DATE: 16 April, 2001
REVISION: Orig.
AIRCRAFT: PITTS SPECIAL

SUBJECT: Aileron Cove Fabric Retention Strips

Pitts S-2C

Figure 1. Strip Orientation

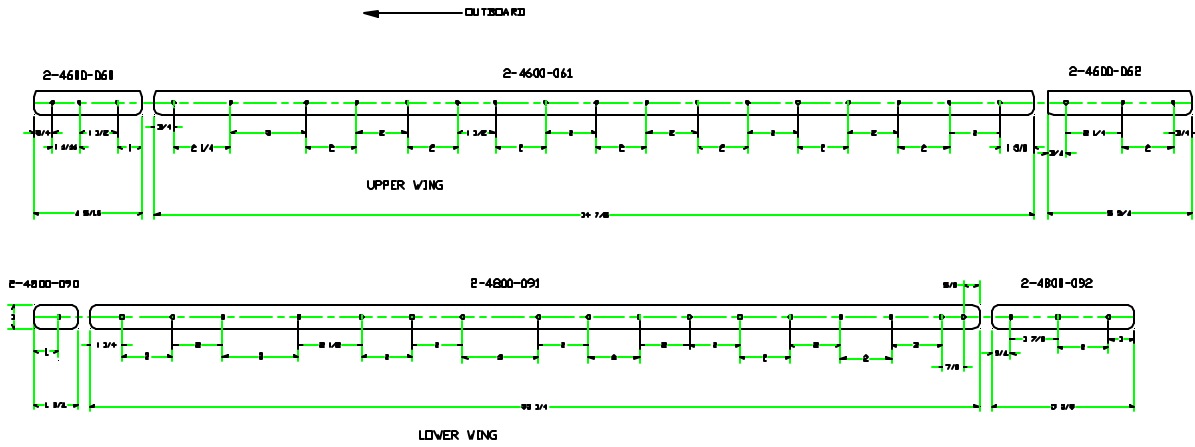
Several Pitts S-2C aircraft have experienced delamination of the fabric in the aileron coves, causing it to chafe the leading edges of the ailerons

1. Tape retention strips into the center of the cove, aligned per the drawings on Appendix A. The strips must be oriented per the drawing to avoid drilling into the nailing blocks.
2. Match drill #40 holes through aileron cove.
3. Install SSP-32 blind rivets in all holes.
4. Remove tape
5. Paint if desired
